Portland Community College

Opportunity Center

OAC Meeting
February 15 2021

PCC Metro Center OAC Meeting

CMU BUILDING BASE

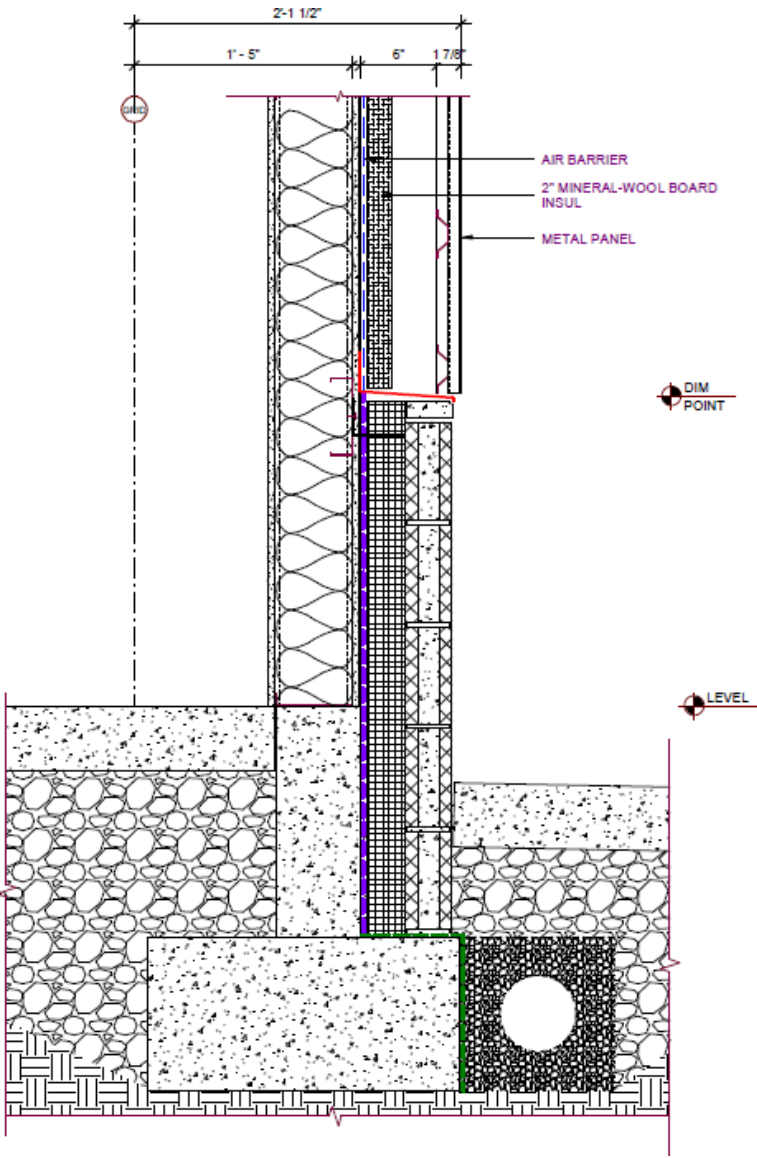
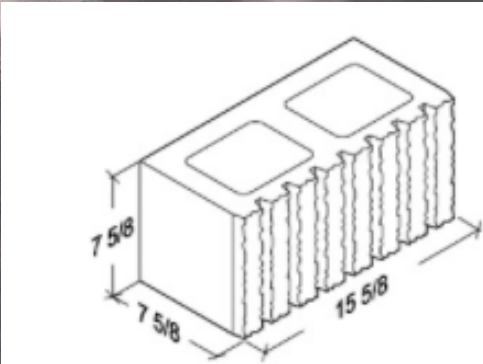
Change from poured architectural concrete to CMU building base - Confirm

- c. Building base was changed from poured concrete to CMU.
- i. Significant savings were achieved, and the design team is happy with the texture it brings to the façade.

- ii. Bora studied multiple options for texture and block type. Block options are limited because we need a specific dimension to achieve the intended façade appearance.

- iii. FMS is concerned about the fluted concrete being chipped away or vandalized – harder to repair/clean. PCC is approving CMU as general material direction for the building base. Design team to do further investigations into face/surface options.

- a. Bora/Andersen to investigate examples at other institutions for best practices in regards to operable windows/actuator.
- b. Bora to review types and faces of CMU for the building base.
- c. Bora to design detached benches under canopy for review.
- d. Bora/Andersen to research Parklex and consider other options that are locally available as cladding option.
- e. Bora to provide Gina with updated renderings for newspaper by EOD Friday February 26.

BENCHES

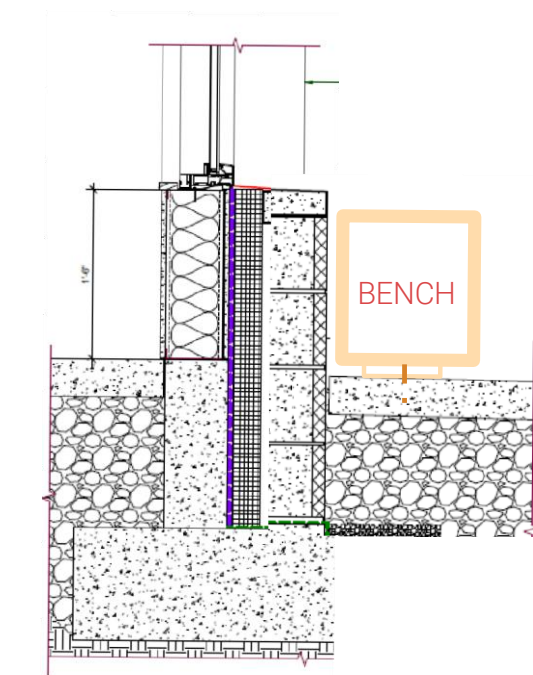
PCC FEEDBACK: DETACH FROM FACADE

RECOMMENDED CUSTOM
BENCH BOLTED SECURED BUT
NOT ATTACHED TO BUILDING

3 LOCATIONS ALONG
KILLINGSWORTH

- d. Exterior benches have been detached from the façade.
- i. Three freestanding (but bolted down) benches will be provided along the south façade, all covered by canopies. Due to grade challenges on 42nd, the bench on that side has been deleted entirely.

- ii. Exact look/materiality of benches TBD.
 - iii. There could be a relationship between the benches and the pods – Colloqate suggests potential economy of scale in the fabrication of those elements.
